PLAN COMMISSION REPORT

10Proposal: Preliminary Subdivision Plat – Parkside Subdivision

Description: Review a preliminary subdivision plat for Parkside single-family residential subdivision.

Address(es): 1340 E. Forest Hill Avenue. (3rd Aldermanic District)

PRELIMINARY PLAT PARKSIDE SUBDIVISION

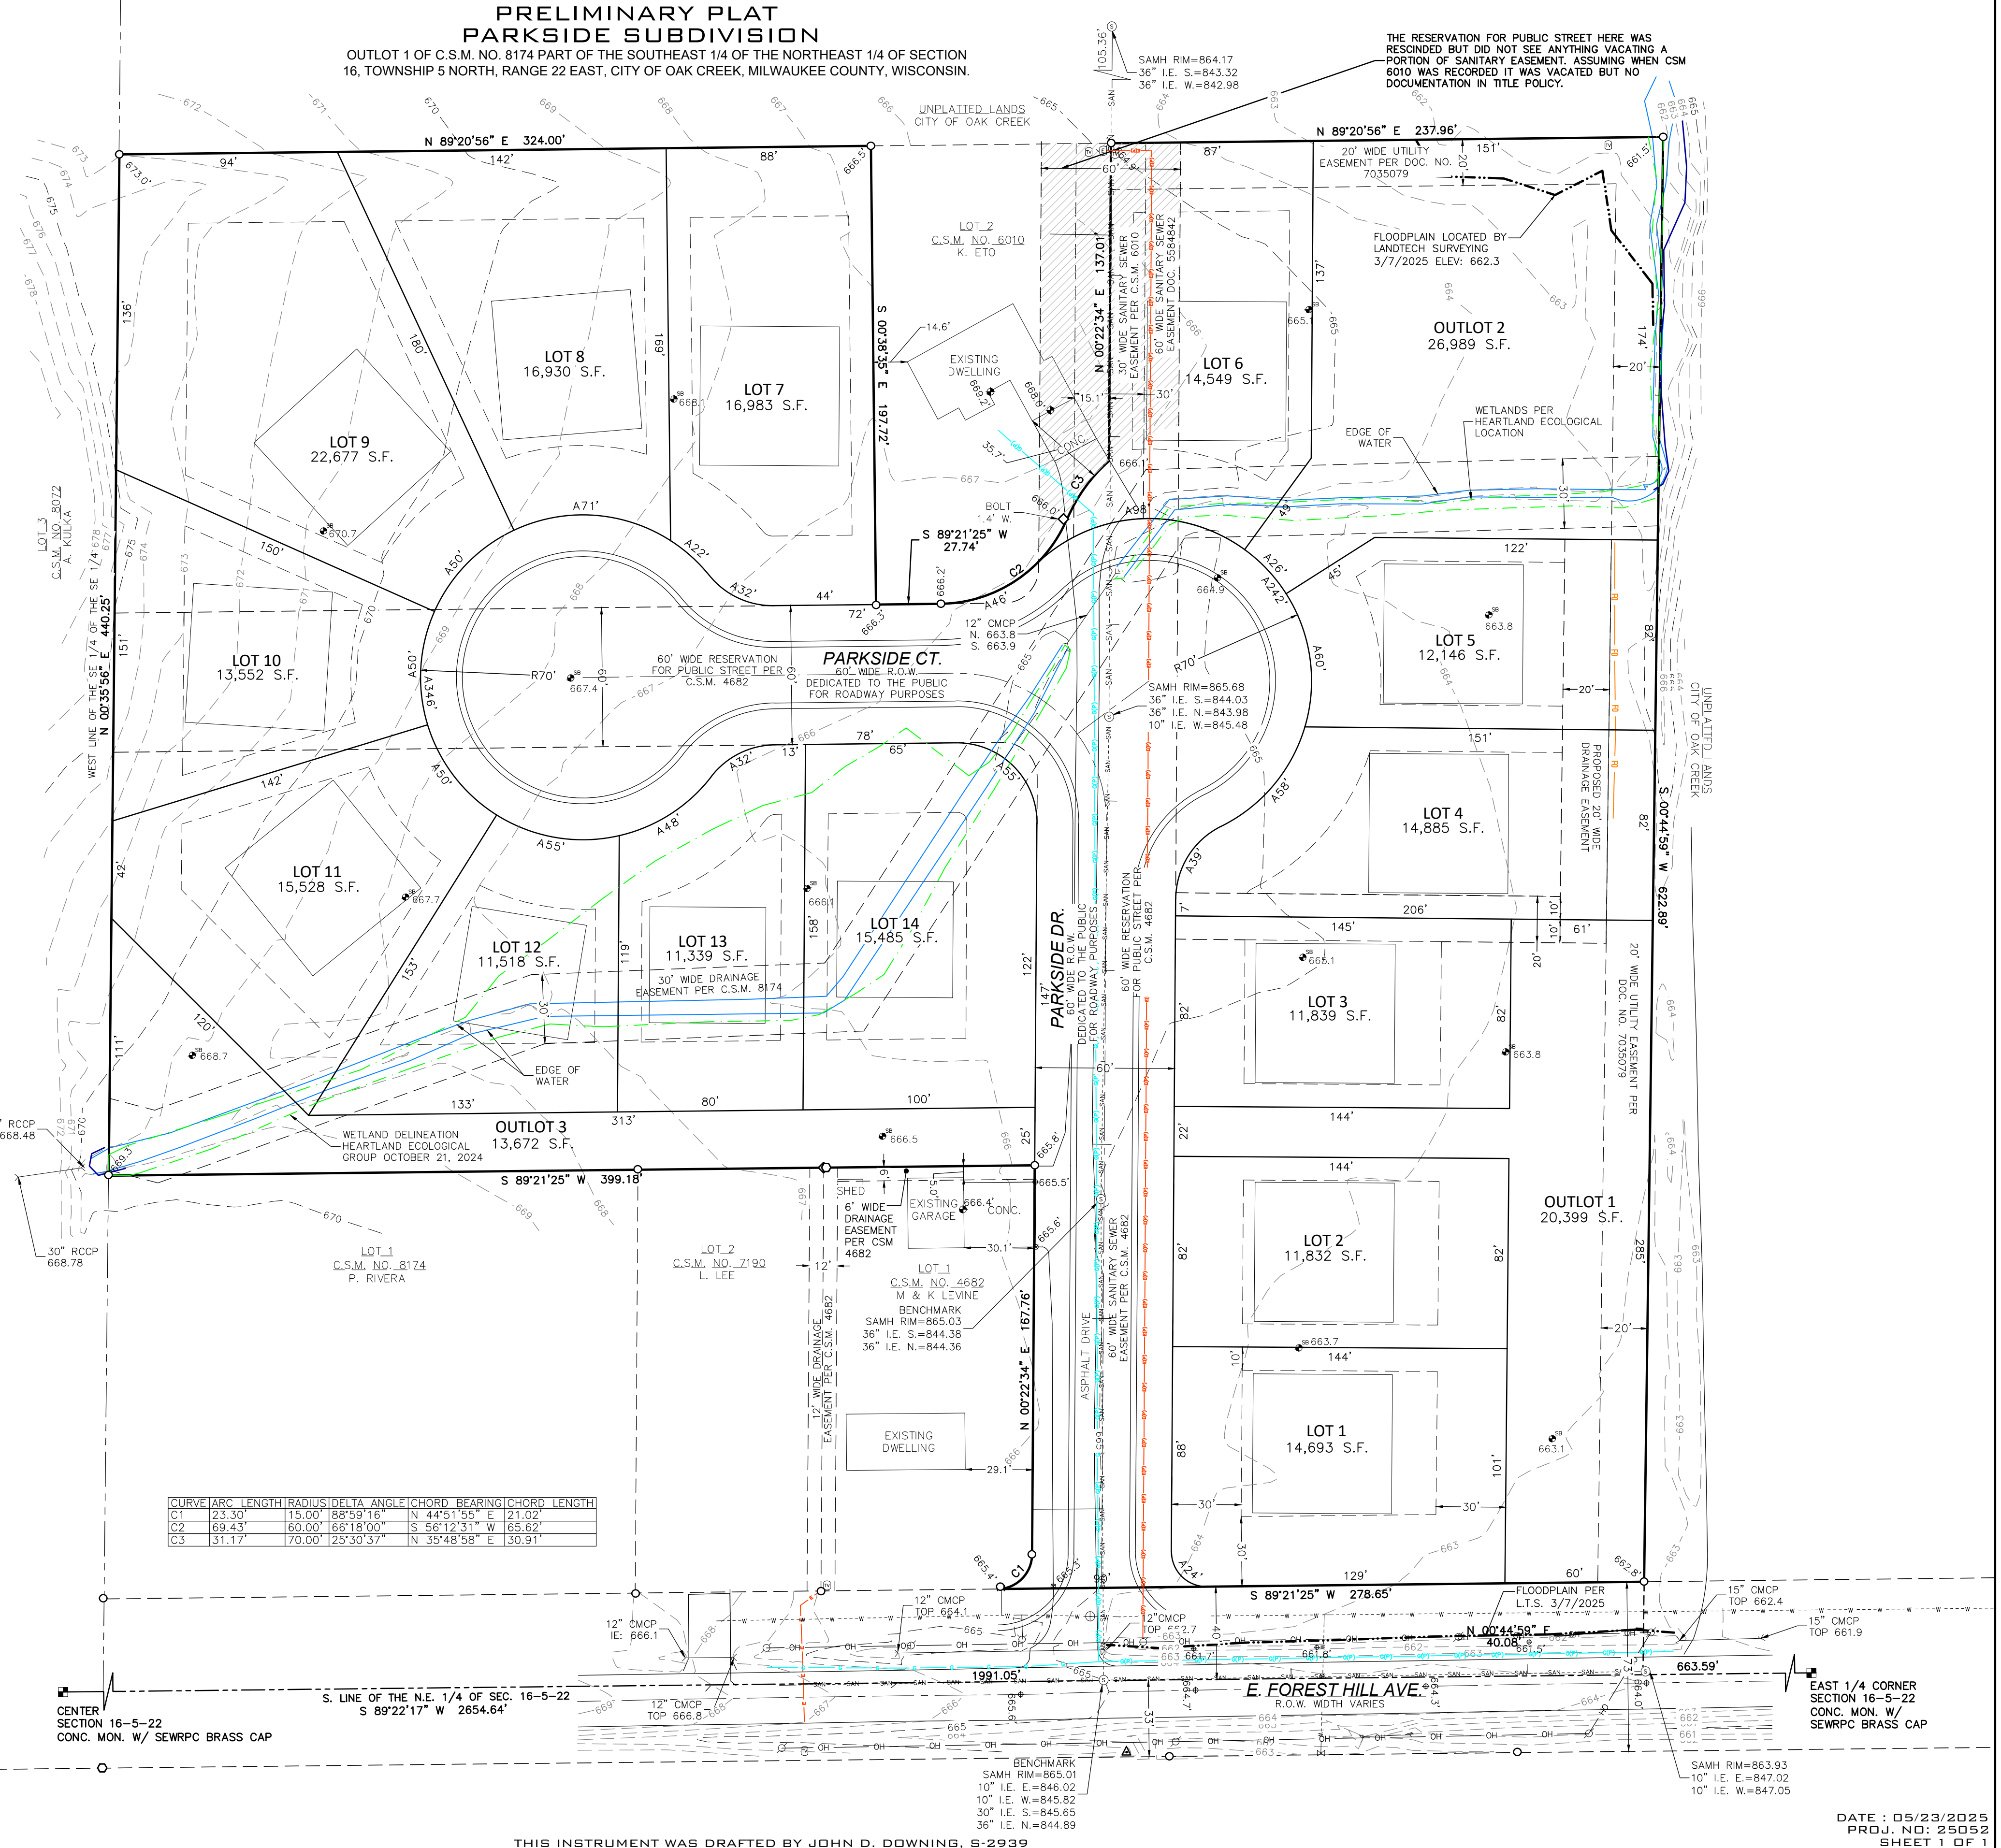
Additionally, sidewalks are not shown as required. Per Section 17.0504 of the Municipal Code, sidewalks are required along all sides of lots that abut public streets and as directed by the City Engineer, where existing right-of-way allows. As currently proposed, the preliminary plat does not meet City requirements for sidewalk installation.

1. Sidewalks are not shown as required per Section 17.0504 of City Code, which states: “Sidewalks shall be provided along all sides of the lot that abut a public street and as directed by the City Engineer, where the existing right-of-way permits.” This does not meet Code requirements and must be revised.

2. The locations of light poles are not shown per 14.108 of City Code.
3. There is only one (1) access point into the subdivision. Per Section 14.120(h)(2)d. for roads with permanent cul-de-sacs, “*More than one (1) access road shall be provided when access by a single road could be impaired due to vehicle congestion, terrain conditions, climate conditions, or other factors that could limit access in accordance with NFPA 1, Chapter 18.2.3.4.1.1..*”

4. The site contains an existing 30 foot wide drainage easement which is noted to be vacated. Relocation of this drainage easement has not been addressed by the Applicant.

5. City Engineers have noted that the site has steep slopes affecting driveways and ground water issues affecting the buildable areas of future homes. Per Section 14.41 of City Code, “*...No land shall be subdivided for residential, commercial or industrial use which is held unsuitable for such use...for reason of flooding, inadequate drainage, adverse soil or rock formation, unfavorable topography or any other feature*

1. Lots 12, 13, & 14 are in a wetland and drainage ditch. Potential future filling of the wetland will not change the ground water. Underground water movement will still be right through the basements of homes built upon these lots.

1. The Applicant must provide a geotechnical report to support the infiltration rates assumed in WinSLAMM. Additional data such as ground water elevations throughout the site would also be beneficial to better understand the vertical distance separation between basement elevations and groundwater.

1. The slopes around many of the building envelopes appear to be undesirable. Concerns with functionality for future homeowner.
2. Stormwater features along lot lines, 10-ft from a home is concerning/undesirable.
3. Multiple proposed Lots include public easements. Accessory structures and fences are not permitted within any public easement that has infrastructure (sanitary sewer, water main, storm sewer). Residents tend to be disappointed when they apply for a permit and are provided that information.

4. Driveway approaches may have a maximum slope of 7%, sidewalk slopes are a maximum of 2%, therefore in some locations the driveway slope on the private property side appear to exceed 10%, which is undesirable.
5. There are concerns with curve standards for the proposed roadway. The Applicant needs to review the WisDOT FDM regarding horizontal and vertical curve standards for the proposed roadway alignment. Vertical curves must be a minimum of 100-ft.
6. Many previous single-family developments have included an island within the cul-de-sac. We are in the process of updating the City's Design manual and this will be a requirement.

1. Owner noted on plat differs from ownership of record. This should be corrected or deed(s) recorded prior to recording subdivision to avoid delay in processing. Last deed attached for reference.
2. Be sure roads dedicated on plat are accepted by municipality.
3. Note on left panel indicates 15 lots, however the plat shows 14.
4. Regarding the abutting CSMs noted on the prelim, CSMs 4682, 6010 and 7190 are all described as Lots however these were recorded as Parcels.
5. There is no legal description on plat. A legal description is required.

1. Review fee of **\$150** does not appear to have been paid. Please remit by sending to the attention of **Kristine Kampa at 901 N. Ninth Street; Rm 103, Milwaukee, Wisconsin 53233** to avoid delay in recording/processing.
2. Owner noted on plat differs from ownership of record. This should be corrected or deed(s) recorded prior to recording subdivision to avoid delay in processing. Last deed attached for reference.
3. Be sure roads dedicated on plat are accepted by municipality.
4. Note on left panel indicates 15 lots, however the plat shows 14.
5. Regarding the abutting CSMs noted on the prelim, CSMs 4682, 6010 and 7190 are all described as Lots however these were recorded as Parcels – they may want to update this.
6. No legal description on plat. Please include if this was an oversight.

1. That all relevant Code requirements remain in effect.
2. That the preliminary plat is revised to show the sidewalks with a minimum width of five (5) feet along all sides of the lots that about a public street per Section 17.0504 of City Code.

TREE PRESERVATION EXHIBIT

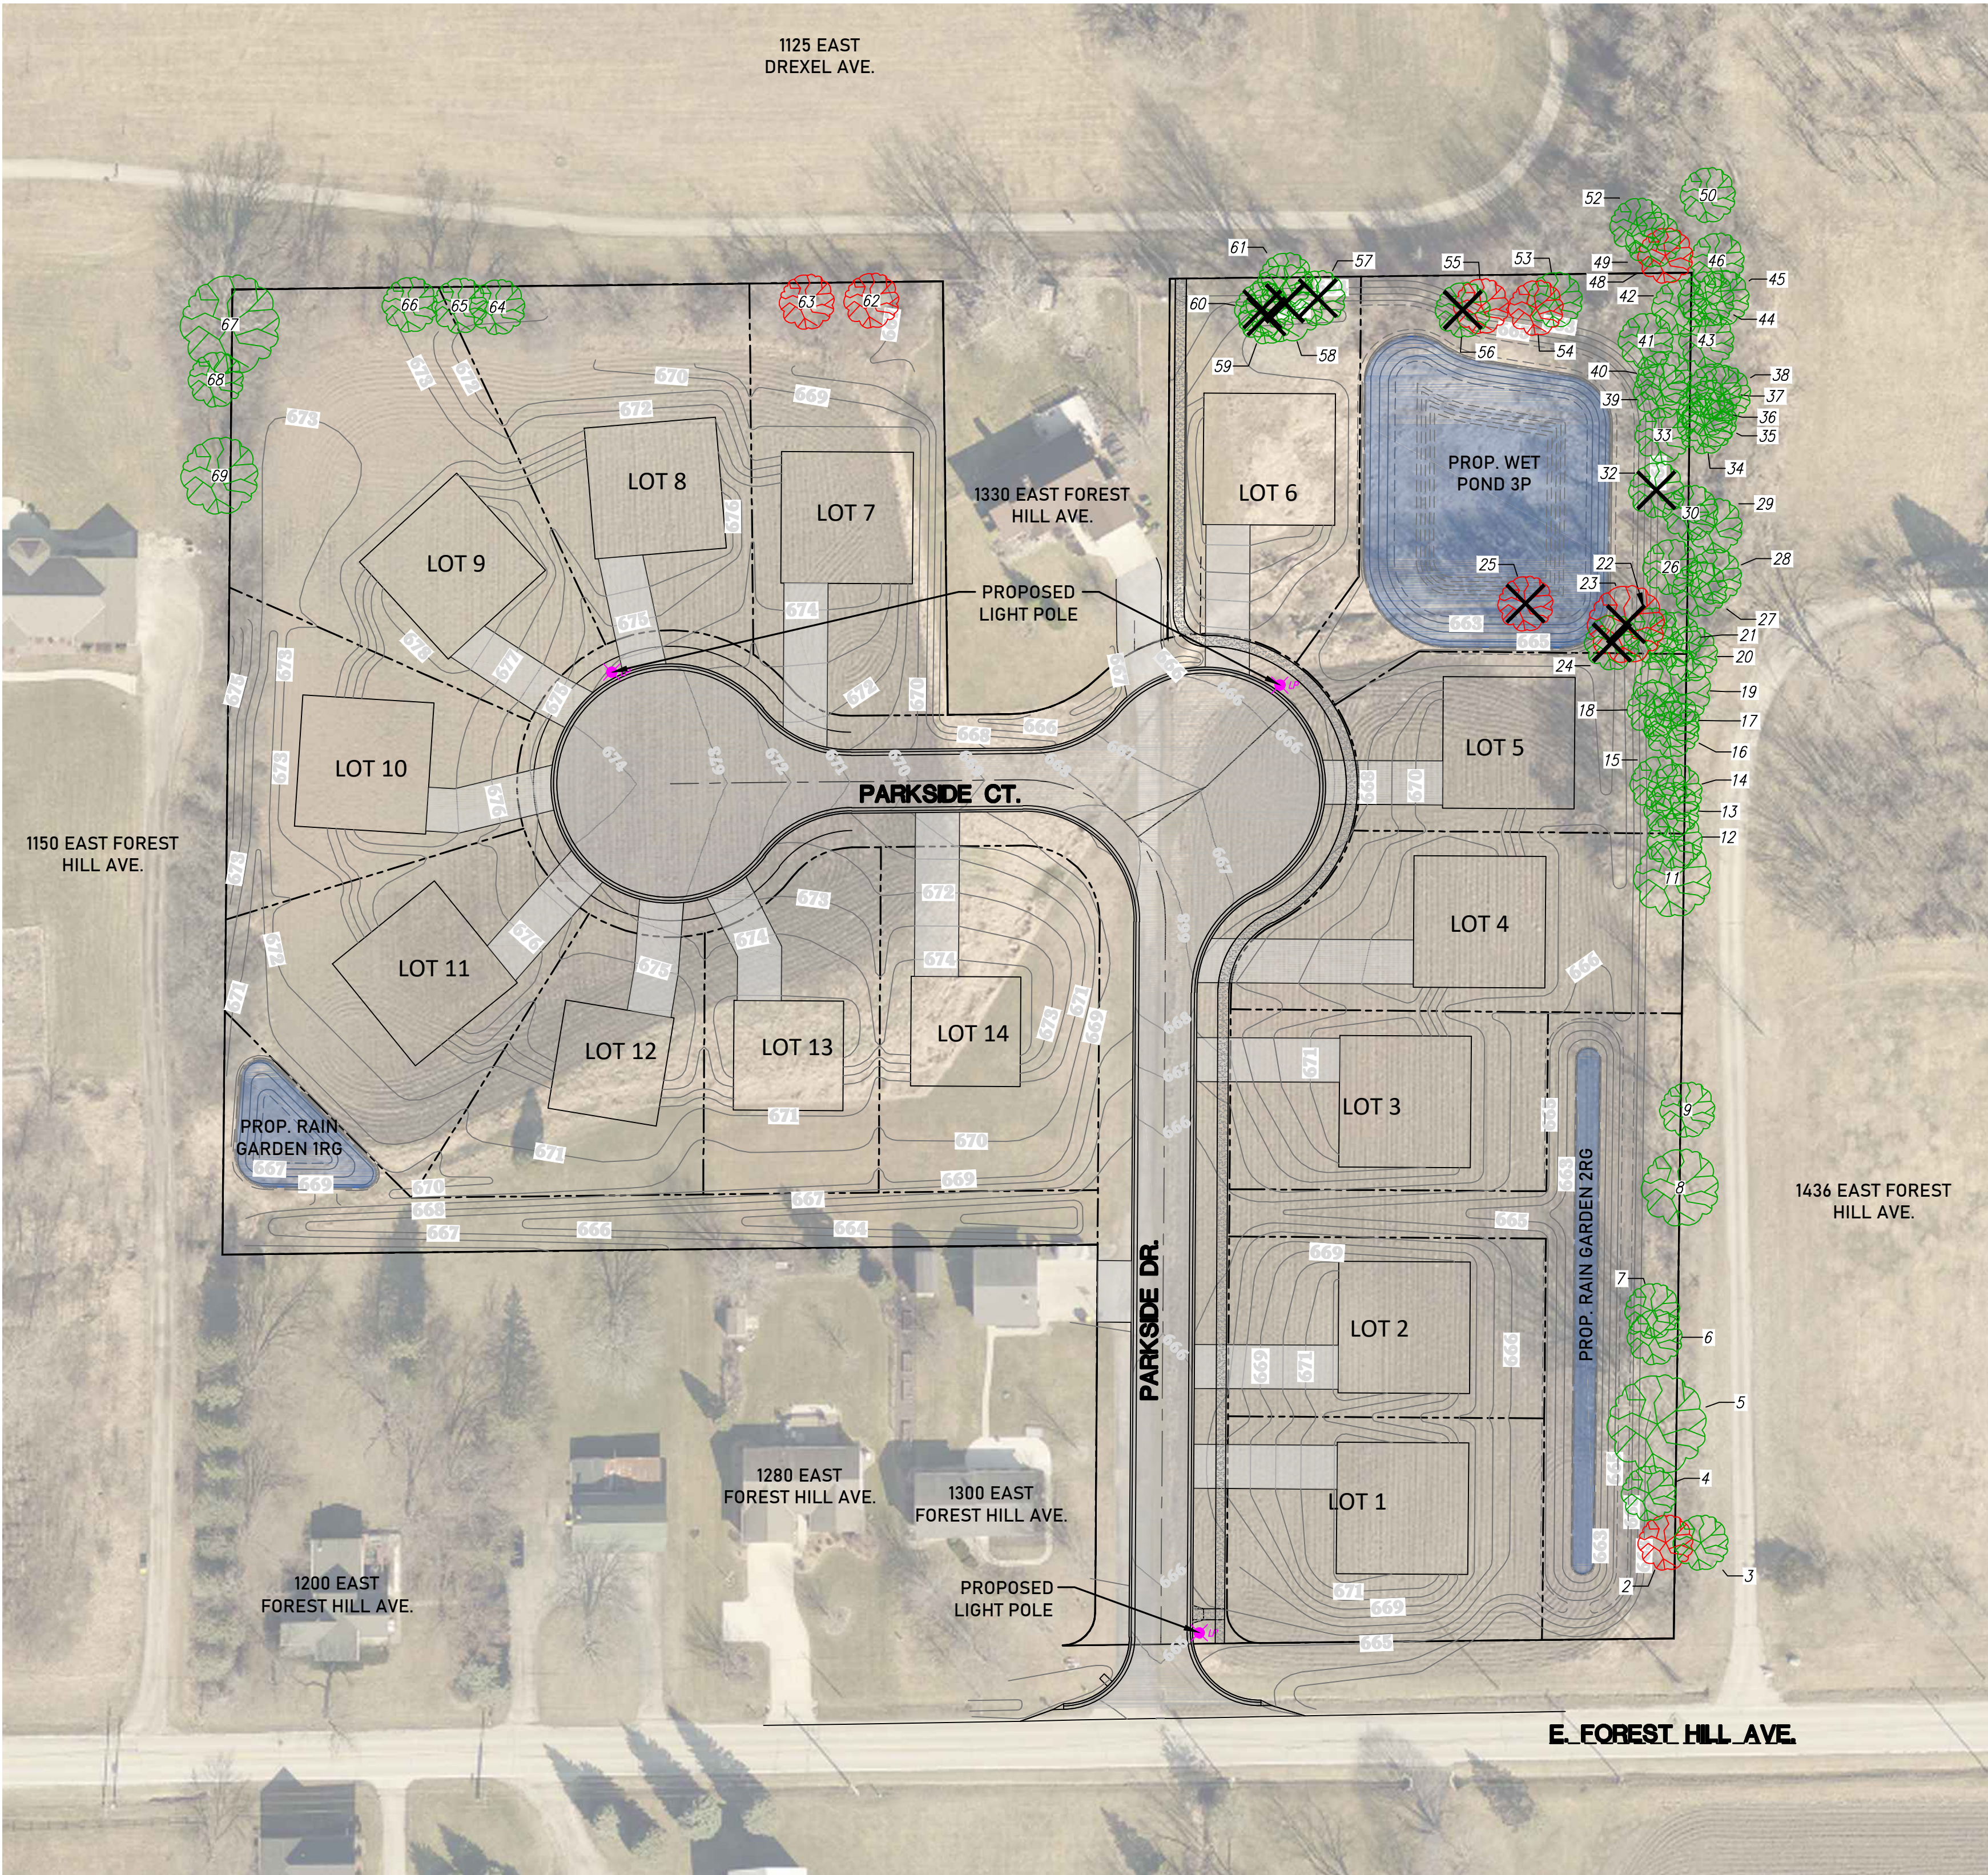
Lighting: Street lamps are required per Section 14.108 of City Code. As shown on the Tree Preservation Exhibit, the Applicant is proposing the installation of three (3) pole-mounted street lamps within the subdivision: one at the entrance, one at the street elbow, and one within the proposed cul-de-sac. All street lamps must conform to the City of Oak Creek's Department of Public Works decorative residential lighting standard.

Landscaping: The Applicant has submitted a tree preservation exhibit for the proposed subdivision showing the existing trees on site. According to the exhibit, five (5) trees—each with a diameter between 12 and 29 inches at breast height—must be removed to accommodate the development.

A detailed landscape plan has not been submitted. This plan must include the proposed landscaping layout, along with the locations of both the required replacement trees (per Section 17.0505(d)) and the street trees (per Section 14.110).

6. The Applicant has not submitted a landscape plan to address the following:
 - a. The Applicant has provided an inventory of all trees of twelve (12) inches or greater at breast height and indicated that they will be removing five (5) that meet requirements for tree preservation. Per Section 17.0505(d)(4), the Applicant must replace the trees at a ratio of 3:1 (a total of 15 trees) within one year of the date of approval. The Applicant has not provided a landscape plan to show where these trees will be planted on site. Similarly, Section 14.41(b) states: *"The subdivider shall make every effort to protect and retain all existing trees, shrubbery, vines, and grasses not actually lying in public roadways, drainageways, building foundation sites, private driveways, soil absorption waste disposal areas, paths, and trails. Such trees are to be protected and preserved during construction in accordance with sound conservation practices, possibly including the preservation of trees by well islands or retaining walls whenever abutting grades are altered, pursuant to a landscaping plan filed by the subdivider."*

- b. Per Section 14.110 of City Code, the subdivider shall plant street trees along all streets within the subdivision as required by Table 14.103 of City Code. The Applicant has not provided a landscape plan to show where these trees will be planted on site.

3. That the Applicant provides a detailed landscaping plan, including location, quantity, and species of trees as required by Section 14.110 and Section 17.0505(d) of City Code.
